STAFF REPORT

SUBJECT: H-2021-0007 – Seasons at Meridian/Winco Wells Subdivision
H-2020-0118 – Volante Investments

LOCATION: 2600 & 2700 E. Overland Rd., in the SE ¼ of Section 17, Township 3N., Range 1E. (Parcels: S1117438626, S1117438451)

A. Preliminary Plat (date: 02/4/2021) & Phasing Plan

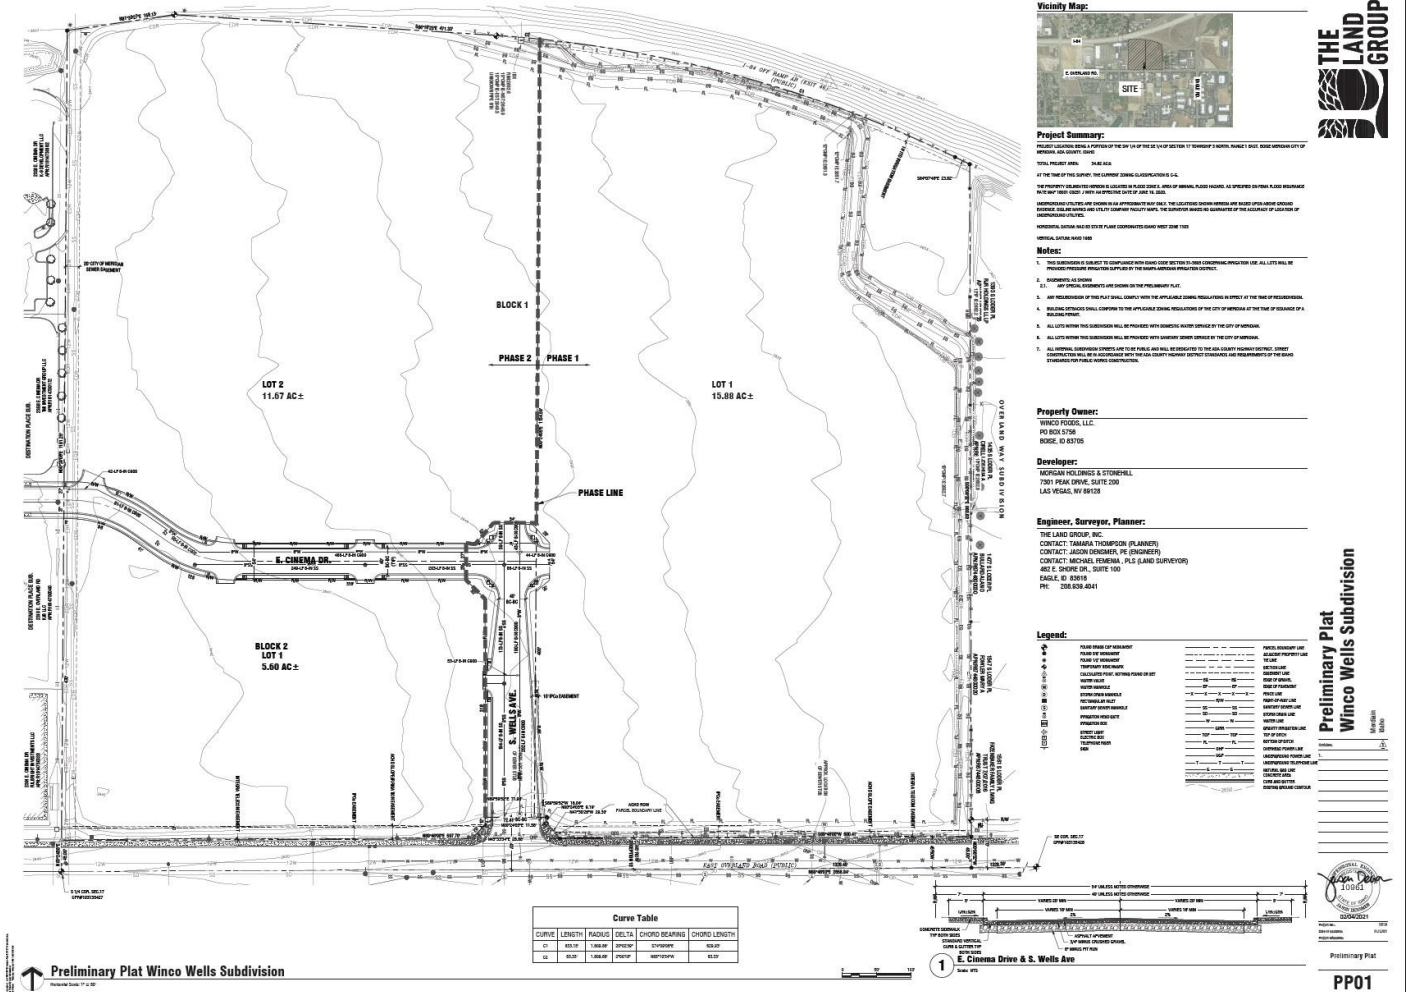
The proposed preliminary plat consists of 3 buildable lots on 34.62 acres of land in the C-G zoning district and is proposed to develop in two (2) phases (see Section VIII.A). The first phase consists of the extension of S. Wells Ave. to E. Cinema Dr. and includes the east parcel; the second phase consists of the extension of E. Cinema Dr. from Wells to the west boundary of the site and includes the west parcel. Right-of-way for the extension of S. Wells Ave. and E. Cinema Dr. is proposed to be dedicated with the plat.

In order to provide interconnectivity between uses in a timelier manner and disperse traffic, Staff recommends the extension of E. Cinema Dr. from the west boundary of the site to S. Wells Ave. occurs with the first phase of development.

- b. Modification of the requirement for E. Cinema Dr. to be extended with the first phase of development in favor of the second phase (condition IX.A.3c).

3. The final plat shall include the following revisions:
 - a. All street buffers are required to be placed in a common lot or on a permanent dedicated buffer, maintained by the property owner or business owners' association, as set forth in UDC 11-3B-7C.2b.
 - b. Depict the street buffer along E. Overland Rd. outside of the ultimate right-of-way for the widening of Overland to 7-lanes.
 - c. The extension of E. Cinema Dr. shall ~~be included in~~ occur with the first second phase of development.
4. The landscape plan included in Section VIII.B shall be revised as follows:
 - a. Landscaping is required to be provided adjacent to the pathway within the buffer along the I-84 off-ramp per the standards listed in UDC 11-3B-12C. *A mix of trees, shrubs, lawn and/or other vegetative ground cover with a minimum of one (1) tree per 100 linear feet of pathway is required.*

C. Site Plan for Multi-Family Portion of Development (date: 1/14/2020)

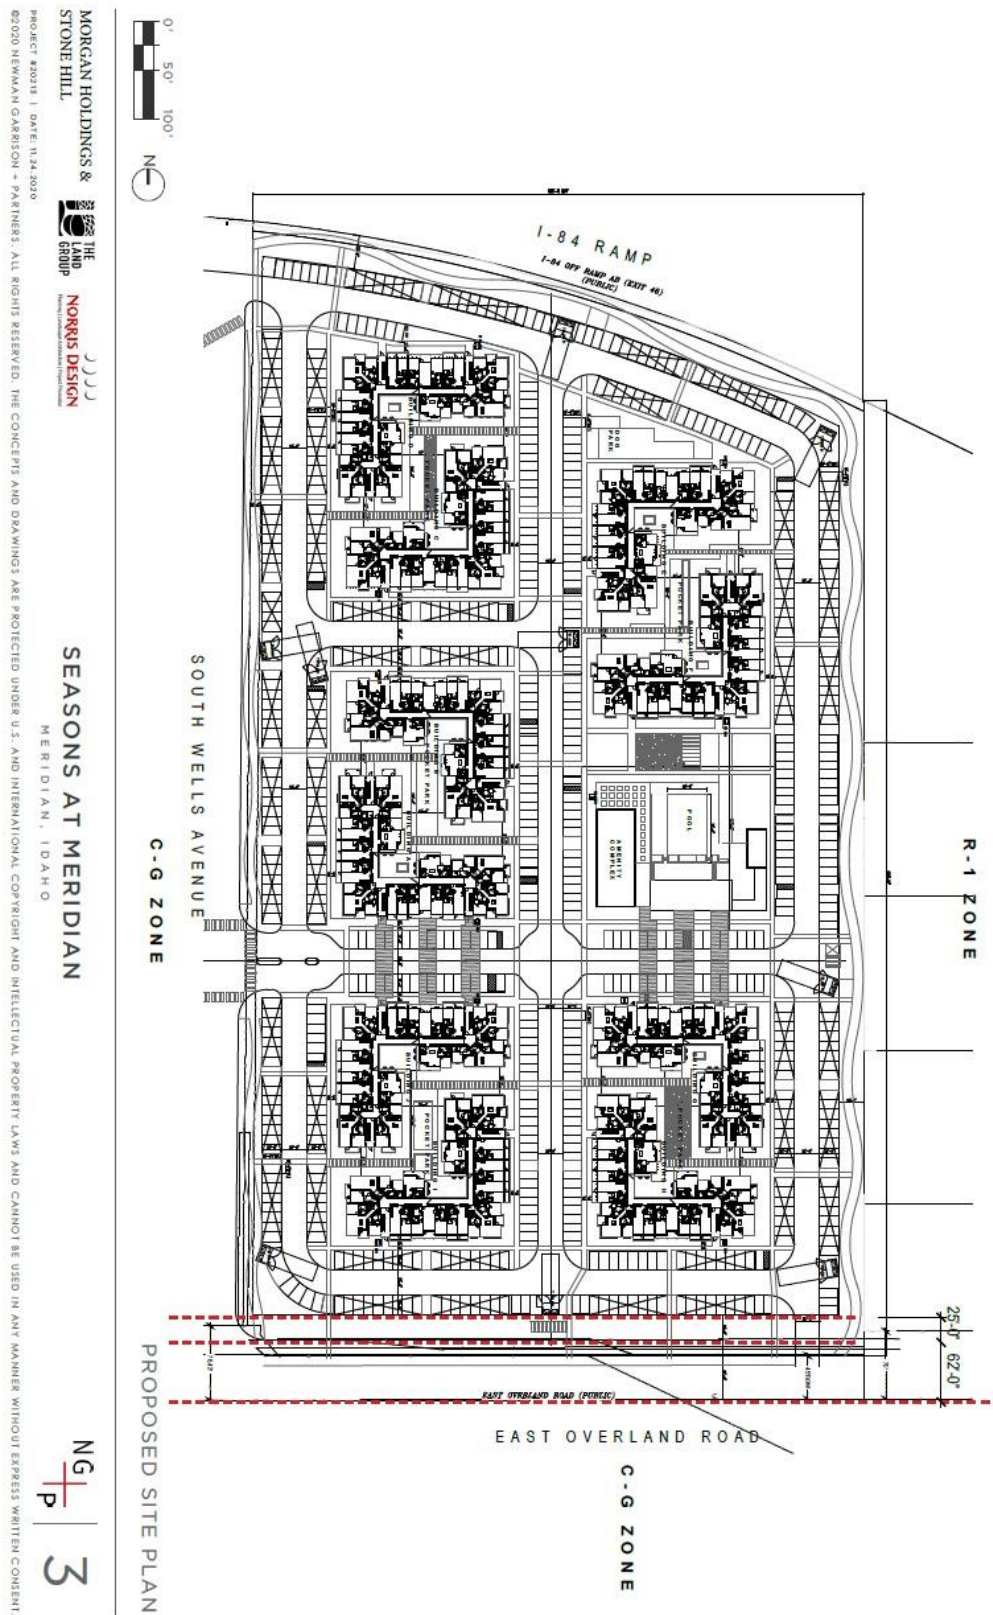
The proposed development plan for the east parcel is a 360-unit multi-family development as shown on the site plan in Section VIII.C. As discussed above in Section V, Staff believes the proposed plan contributes to the mix of uses desired in the MU-R designation and provides a transition and buffer between commercial uses to the west and the low-density residential development to the east (i.e. Overland Way Subdivision). The addition of more residential uses in this area will provide more patrons for surrounding commercial/retail/restaurant and office (medical/dental) businesses as well as offer employment options in close proximity of the residents.

*The Applicant's narrative states these items will be provided; **the site plan submitted with the Certificate of Zoning Compliance application should depict the location of these items in accord with this standard.***

2. A new Development Agreement (DA) shall be required for the east parcel (#S1117438451) that shall include the site plan in Section VIII.C and the following provisions:

- 10. The site and/or landscape plan submitted with the Certificate of Zoning Compliance shall be revised as follows:
 - a. Depict the locations of the property management office, maintenance storage area, central mailbox location (including provisions for parcel mail, that provide safe pedestrian and/or vehicular access), and a directory and map of the development at an entrance or convenient location for those entering the development in accord with UDC 11-4-3-27B.7.

D. Landscape Plan for Multi-Family Development (CUP) (dated: 11/24/20)

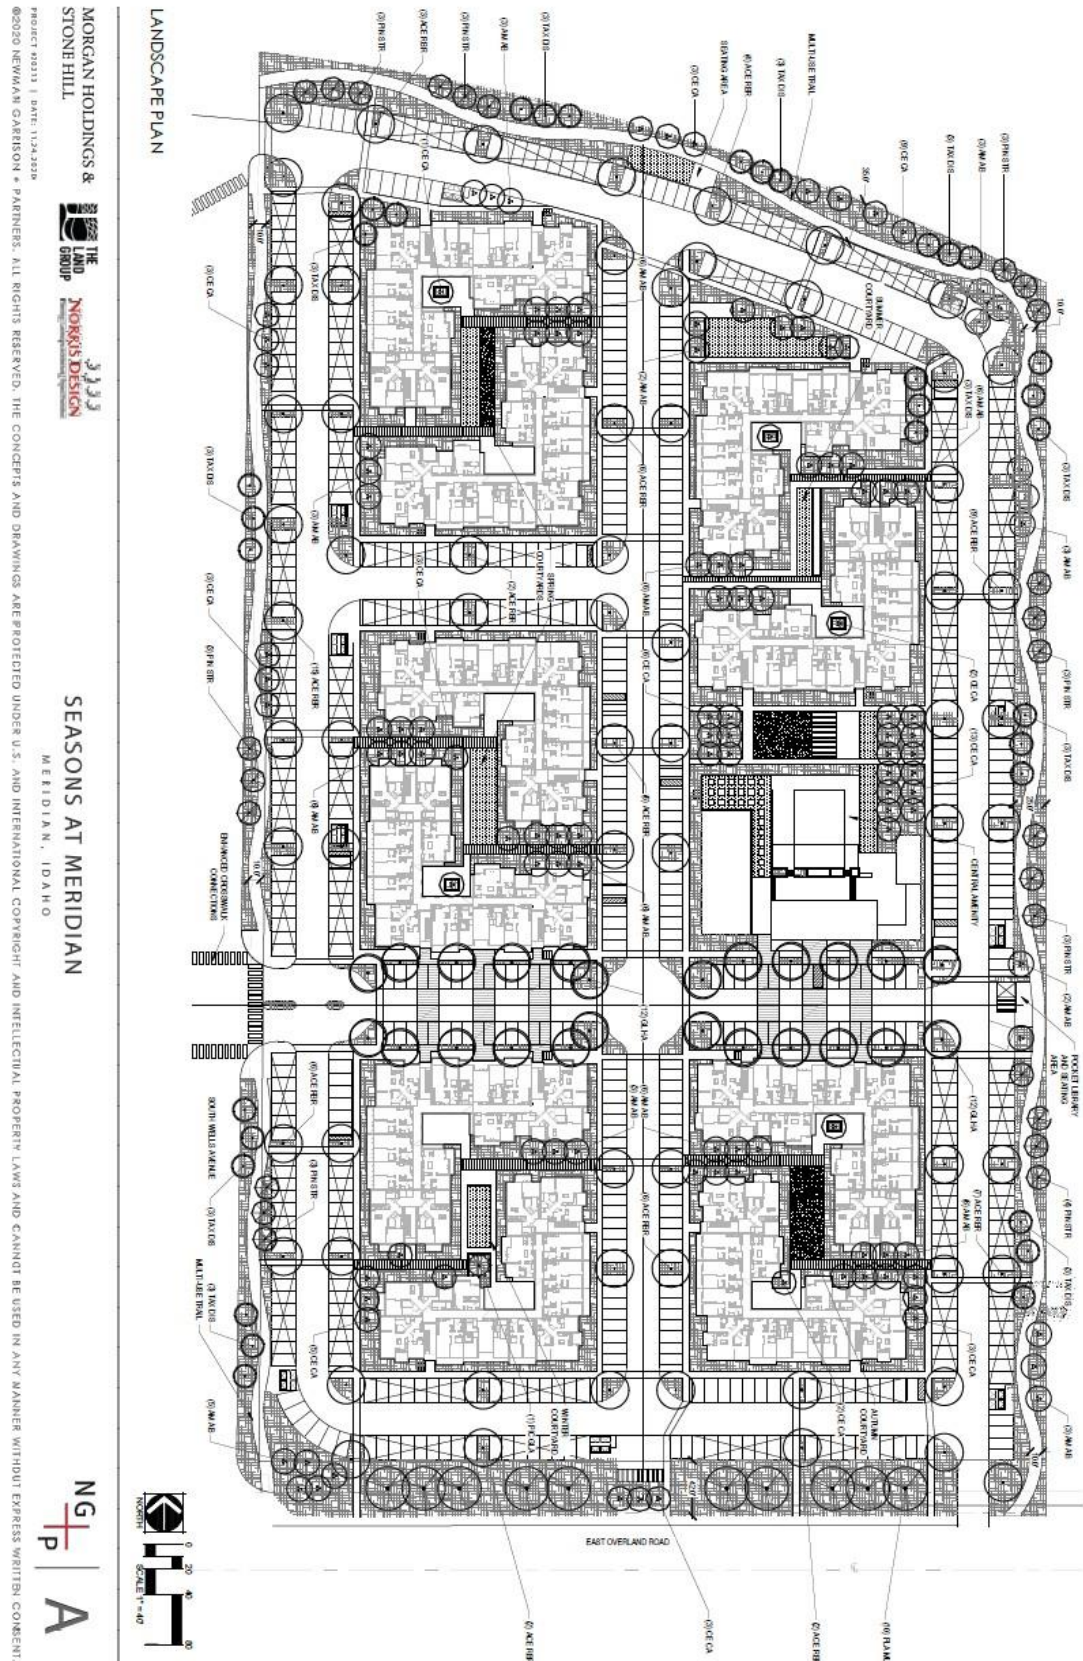
Street buffer landscaping is required to be provided with the subdivision in accord with the widths specified in UDC Table [11-2B-3](#) for the C-G zoning district and planted in accord with the standards listed in UDC [11-3B-7C](#). A landscape plan was submitted for the proposed subdivision landscaping, included in Section VIII.B.

Required street buffer widths are as follows: 25-feet along E. Overland Rd., an arterial street; 10-feet along S. Wells Ave. and E. Cinema Dr., both local streets; and 35-feet along the I-84 off-ramp, an entryway corridor. Street buffer widths are proposed on the landscape plan in accord with these standards. **The plan is missing the street buffer along I-84 on the west parcel (Lot 2, Block 1); the plan should be revised to include this buffer.**

The number of trees proposed in buffers meets the minimum standard; however, a mix of trees and shrubs with lawn or other vegetative groundcover is required – shrubs should be added to the buffers in accord with UDC 11-3B-7C.3a. Street buffers are required to be placed in a common lot or on a permanent dedicated buffer, maintained by the property owner or business owners' association; the plat should be revised accordingly.

The landscape plan submitted with the Certificate of Zoning Compliance application should depict landscaping along the street facing elevations adjacent to E. Overland Rd. and S. Wells Ave. in accord with these standards.

Fencing: No fencing is depicted on the landscape plan for this development. A 6-foot tall wood fence exists along the southern portion of the east boundary on the adjacent residential property; Staff is unsure what other fencing may exist to the north of that at the rear of residential properties. A fence is also depicted on the plat along the northern boundary of the east parcel. **The Applicant states a privacy fence is proposed along the east boundary of the site; materials and sizing to be determined pending meeting with neighbors and project approval from the City. Staff recommends prior to the City Council hearing details of the proposed fencing type are submitted.**

- 4. City Council change(s) to Commission's recommendation:
 - a. Include a requirement for a minimum 6-foot tall woodgrain vinyl fence to be installed along eastern boundary of the site as proposed by the Applicant (see condition #IX.A.10f).
